BMPRO MOTOR FUNCTION WIRING

Bulletin Type:	TSB	Publication Date:	October 2022
Bulletin #(s):	22-079	Make(s):	Jayco
Job Code(s):	9801573	Model(s):	Eagle HT TT
Flat Rate(s):	9801573 – .25 Repair	Model Year(s):	2023

Incident:	Exterior Travel lockout switch does not disengage motor functions (jacks, awnings, slideouts, etc.)
Affected Units:	2023 Jayco Eagle HT TT
Parts List:	Parts Kit #: N/A
Misc. Tools & Supplies:	Square Driver, Screw gun, wire strippers, 3 way wago, 14 gauge stranded wire (Shop Supplies)
Parts Return Information:	N/A

Fig. 2

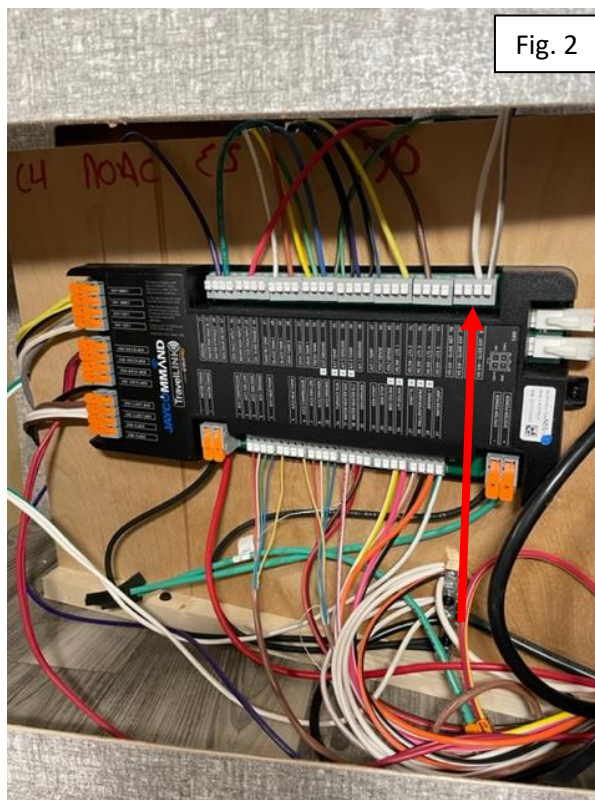
2. Remove the white wire in the #80 slot on the BMPro. (Figure 2)
3. Using (2) 6" pieces of 14 gauge stranded wire, depress the white tabs on the BMPro and insert one into slot #62 and then one into slot #80. Using a 3-way wago, connect the original wire to the two jumpers. (Figure 3)
4. To test the fix, plug the pigtail into a testing box or vehicle and activate the 4-way flashers. While flashing, motor functions should not be functional. Turn the 4-way flashers off. Hit the "retract" button on the front landing legs. (Figure 4) All motor functions should be operable once again.
 - a. Note: This only applies to Eagle HT travel trailers that are equipped with the electric jack option. This does not affect trailers with auto leveling.
